Access Compliance Report Public Rights-of-Way (Curb Ramps)

Main Street: BELLWOOD_RD Cross Street: ANGLER_LN Location: NE

ADA ID: RPRK211209114358 Ramp Type: Type 1 - Perpendicular Diagonal Initial Pass/Fail: Pass Overall Compliance: No Severity Score: 10

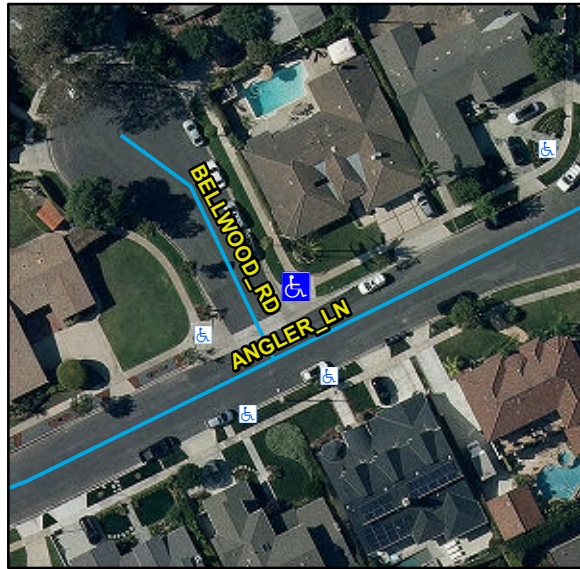
Compliance	Description	Data	Compliance	Description	Data
N/A	Ramp Length (in)	83	N/A	Flare Type LT	
Yes	Ramp Width (in)	48			Sloped
Yes	Ramp Run Slope (%)	5.7	N/A	Flare Slope LT (%)	2.3
Yes	Ramp Cross Slope (%)	0.9	N/A	Flare Traversable LT	No
N/A	Landing Present	Yes	N/A	Flare Type RT	
N/A	Landing Length (in)	48			Sloped
Yes	Landing Width (in)	48	N/A	Flare Slope RT (%)	3.8
Yes	Landing Run Slope (%)	1.5	N/A	Flare Traversable RT	No
Yes	Landing Cross Slope (%)	2.2	No	DWS Provided	No
N/A	Landing Movement Obstructed?	Yes	N/A	DWS Contrast	N/A
	Landing Movement Type	Wall	N/A	DWS Length (in)	N/A
N/A	Landing Shared	No	N/A	DWS Full Width	N/A
N/A	Clear Space	Yes	N/A	DWS Offset Left (in)	N/A
N/A	Clear Space To Crosswalk (in)	48	N/A	DWS Offset Right (in)	N/A
N/A	Marked Crosswalk 1	No	N/A	Marked Crosswalk 2	No
	Crossing 1 Direction	W		Crossing 2 Direction	S
	Marked Crosswalk 1 Width (in)	N/A		Marked Crosswalk 2 Width (in)	N/A

N/A	Ramp Inside Crosswalk 1	N/A	Yes	Ramp Inside Crosswalk 2	N/A
	Crossing 1 Slope (%)	8.6		Crossing 2 Slope (%)	3.6
	Crossing 1 Cross Slope (%)	1.8		Crossing 2 Cross Slope (%)	2.9
Yes	Gutter Ponding	No	Yes	Curb Slope	2.7
Yes	Gutter Lip Height (in)	0		Road Run Slope (%)	3.2
Yes	Gutter Run Slope (%)	3.6		Road Cross Slope (%)	2.1
No	Gutter Cross Slope (%)	4.1			
Yes	Overall Surface Condition: Acceptable		No	Perp Joint Present	No
	Cross Gutter Present?	Yes		Spandrel Present?	Yes
	Replace Cross Gutter?	No		Replace Spandrel?	No

Remove & Replace Curb Ramp With Two New Directional Ramps or Equivalent. Remove & Replace Gutter.

R204.3, R304.2.1, R305, R304.5.3, STD 1115
